LiDAR Quality Assessment Report

Materials Received: 8/30/2012	Project Type: GPSC
· · ·	Project Description:
Project ID: VA-FEMA Region3-Lot3(Allegany) _2012.xml	This task order is for Planning, Acquisition, processing, and derivative
Project Alias(es): MD_AlleganyCo_2012	products of lidar data to be collected at a nominal pulse spacing (NPS) of 1.0 meters. Specifications listed below are based on the <i>"U.S. Geological Survey National</i>
MD_AlleganyCo_2012	<i>Geospatial Program Base Lidar</i> Specification, Version 13 (ILMF)", of which sections I through IV are incorporated by reference to this task order. This specification may be viewed at http://lidar.cr.usgs.gov/USGS-NGP Lidar Guidelines and Base Specification v13(ILMF).pdf. These lidar specifications are required baseline specifications. In addition to the requirements listed below, variations from the specifications will be shown and noted below. For any item which is not specifically addressed, the referenced Version 13 specifications will be the required specification authority. This

Lot 3 of 4 lots.

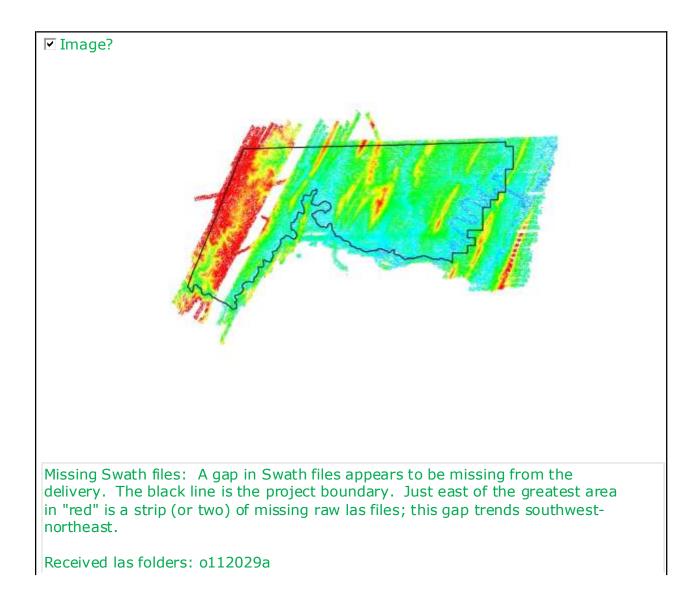
o112029b
o112030a
o112031a
o112031b
o112034a
o112034b

**The missing swath files have been delivered.
